**Town of Kittery  
 Planning Board Meeting  
 May 10, 2018**

**Miller Road – Major Subdivision Sketch Plan Review**

Action: Accept or deny application; Approve or deny sketch plan Owners Paul E. and Peter J. McCloud and Applicant Joseph Falzone requests consideration of a 6-lot conventional subdivision on land along Miller Road (Tax Map 59 Lot 20) in the Residential-Rural (R-RL) and Resource Protection Overlay (OZ-RP) Zones. Agent is Ken Wood, Attar Engineering.

SKETCH PLAN  
MILLER ROAD SUBDIVISION  
MILLER RD. KITTERY, ME

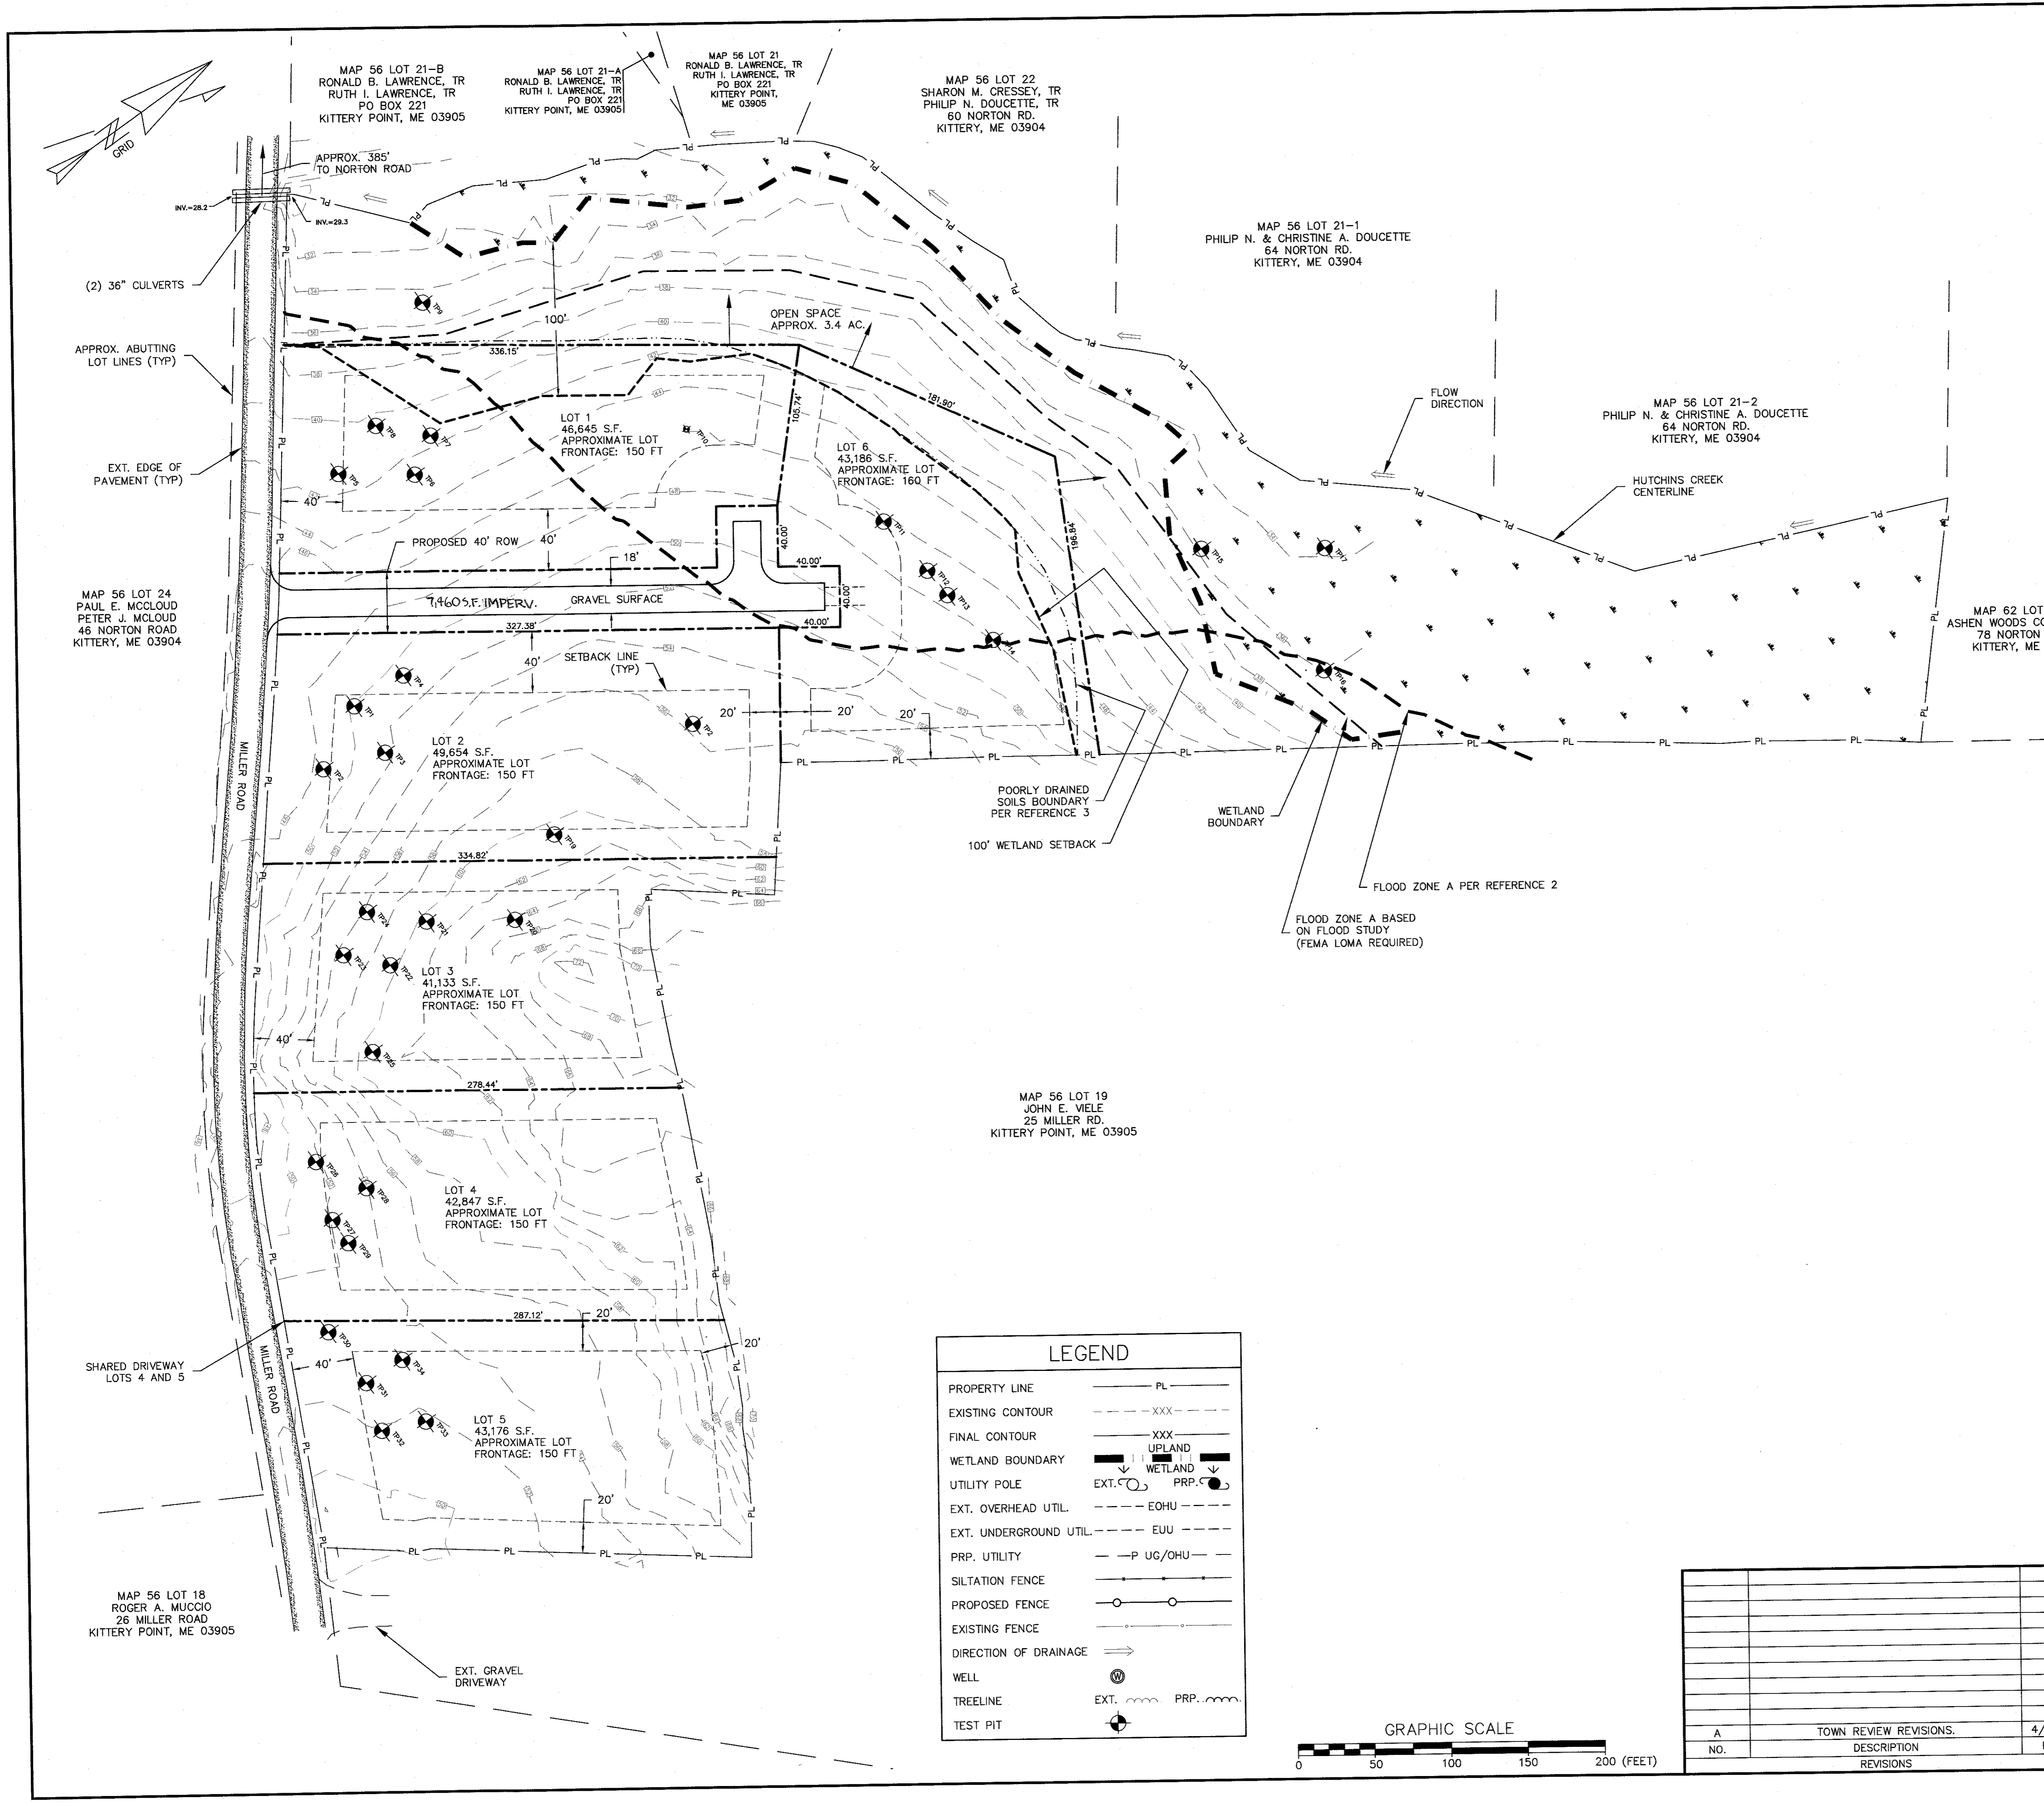
3. **Open Space.** The proposed subdivision plan shows about 3.4 acres of open space along Hutchins Creek to the north which exceeds the 15 % requirement for open space within a conventional subdivision in the Residential Rural Zone (R-RL). **Update: the hammerhead plan shows an open space calculation which appears to meet the requirements, the other designs are not fully rendered so calculations are not available.**

5. **Calculations for Net Residential Acreage.** Per Title 16.7.8 *Net Residential Acreage* has been calculated and is shown as note 6 on Sheet 1 of the plans. It isn't completely clear which of the floodplain areas (the existing or the LOMA-proposed) were used in the calculations as all unsuitable soils are grouped together but presumably the LOMA-proposed area was chosen. **Update: Only the hammerhead plan appears to have this calculation – staff comes up with 252,560 sf available after subtracting the 50% wetland setback, unsuitable soils, ROW/easements and exposed bedrock areas given on the plan from the total parcel area as stated on the plan.**

6. **Dimensional standards.** **Update for the hammerhead plan:** all lots meet the 40,000 sf requirement in the R-RL Zone. Building envelopes are shown. Setbacks (front and side yards) are shown. The 150-foot frontage requirements are met. There are 40-foot setbacks shown for the **three lots that abut the ROW per front yard requirements.** The ROW is itself, 40 feet. **The ROW is separate from the lots it serves, meaning they do not derive any area from the ROW.** There is a hammerhead to allow for turnaround. There was a suggestion at the site walk that the hammerhead could be reversed to allow moving the building envelopes on Lot 1 and 6 farther away from the wetland setback. Impervious surface would be 7,460 sf. Cul-de-sac plan: it shows that the three lots meet their frontage requirements and include the 40-foot setback from the ROW. Impervious surface would be 8,935 sf. Cluster Plan: this plan shows less detail but would be 11,425 sf of impervious surface.
